Technical Car Construction Regulations Rule Changes for 2019

Version 1.0 (Published) – 12th October 2018

**Document compiled on behalf of BriSCA F2 by: Adrian Blackwell
BriSCA F2 Chief Technical Consultant**

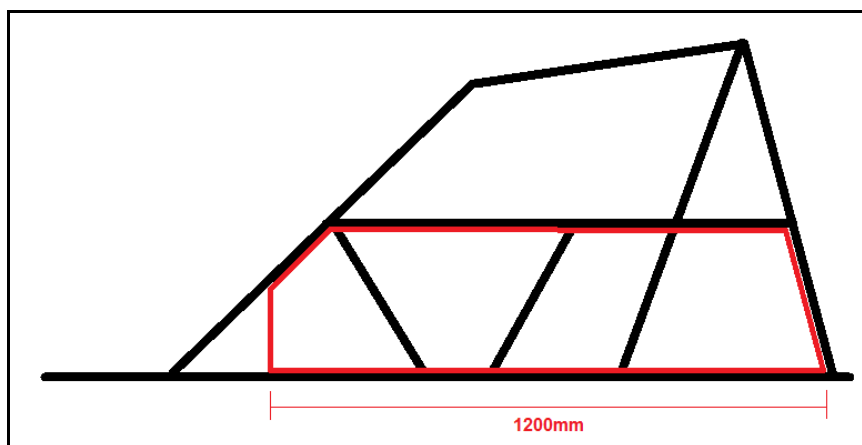
- *BOTH sides of the roll-cage MUST be plated in steel plate (with a MINIMUM thickness of 2mm) to fully enclose the area bordered by the main chassis rail, the rear roll-cage pillar, the side window bar, and the front roll-cage pillar (or an additional down-bar as necessary to meet dimensional requirements).*

- *The plate MUST be fitted as either a single piece (formed as required), or up to a MAXIMUM of 3 pieces on each side of the car (for easier fitment on non-flat cab sides).*

- *The plate MUST be fitted to the outside of the roll-cage/window-bar/down-bars, or inset NO MORE than a MAXIMUM of 5mm from the outer edge of the tube.*

- *The plate (each plate section) MUST be fully welded to the roll-cage structure along the full length of each of its sides (in the same manner as the existing rear panel).*

- *The area covered by the plate MUST measure at least a MINIMUM of 1200mm in length, from the rearmost point where the rear roll-cage pillar meets the chassis rail, horizontally, to the vertical plane where its front-most point meets the chassis rail.*

- *Should the roll-cage be less than 1200mm in length, i.e. the 1200mm measurement extends forward of the front roll-cage pillar, then an additional steel bar (minimum 25mm CHS/SHS x 2.5mm wall), MUST be welded around the exposed forward/upper edges of the plate, and link the chassis rail to the front roll-cage pillar.*

- *As the plate must be welded to the window-bar along its top edge and chassis rail along the bottom edge, then the plate height will be determined by the height of the window-bar (see separate rule change for 2019).*

- *The front edge of the plate must be vertical, or angled forward, from the point at which it meets the main chassis rail, up to the front roll-cage pillar, the window bar, or the required additional bar (depending on the size of the cab).*

- *See Technical Diagram 01 for a visual guide to the above changes.*

Window Bar Height

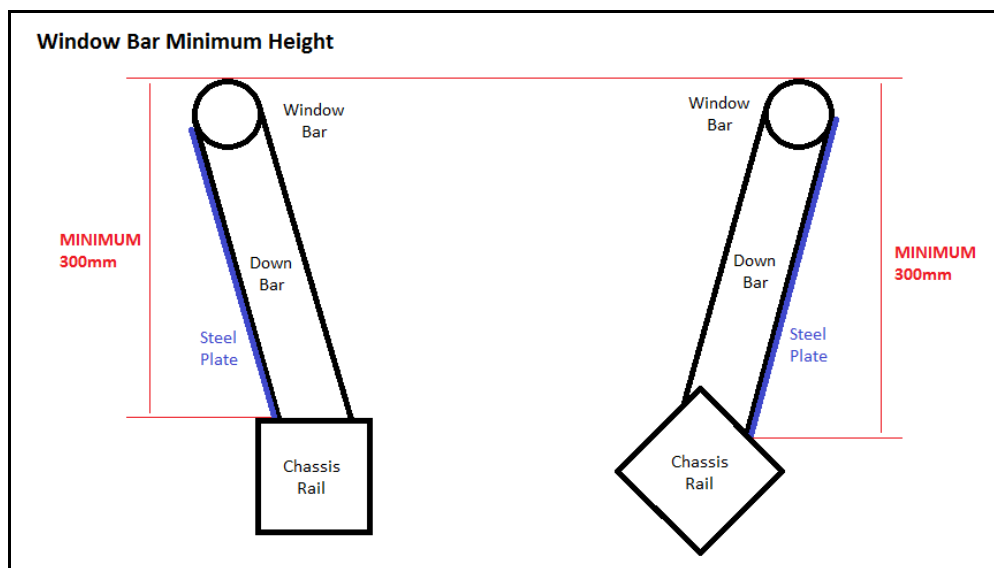
- Side window bars **MUST** measure a **MINIMUM** height of 300mm vertically from the top of the bar (excluding bodywork panels) to the point at which the steel side-plates are welded to the main chassis rails.

- The minimum measurement applies to all points along the length of the window bar, from the front roll-cage pillar to the rear roll-cage pillar.
 - In the case of cars with a “diamond chassis” type design, e.g. the HCD Dozer, the measurement will be taken vertically from the top of the window bar (excluding bodywork panels) to the point at which the vertical would intersect with the main chassis rail in a traditional flat ladder-chassis type design. Cars employing the “diamond chassis” type design, will already be carrying larger foot protection side-plates than cars with a traditional flat ladder-chassis, and therefore this method of measurement will just ensure competitive parity.

- See Technical Diagram 02 for a visual guide to the method of window bar height measurement.

Undercarriage – Definition

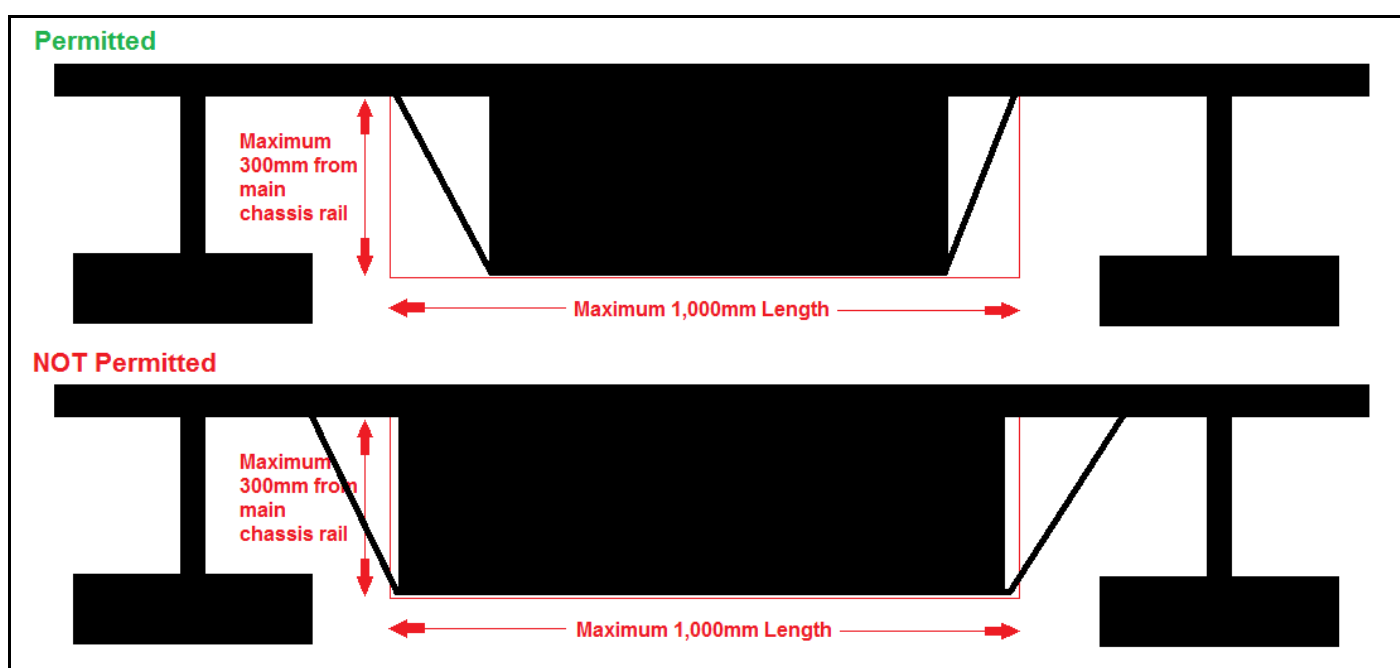
- A clearer definition of the “space-frame undercarriage” of the car will be given. The undercarriage must be constructed from hollow section (CHS, SHS, RHS, OHS) with metal panel-work as required. The construction of the undercarriage from steel plate is not permitted.

Nerf Rails – Tapering

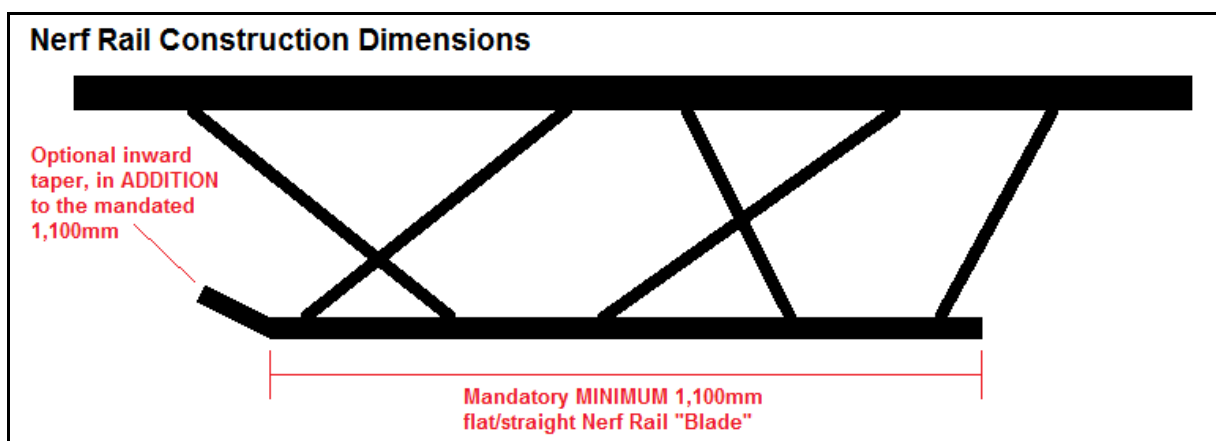
- The tapering-in of the front ends of the nerf rail blades, to prevent hooking up on fence-posts or other cars, will be expressly permitted as this is seen as a benefit to drivers in terms of avoiding damage and thus reducing cost.
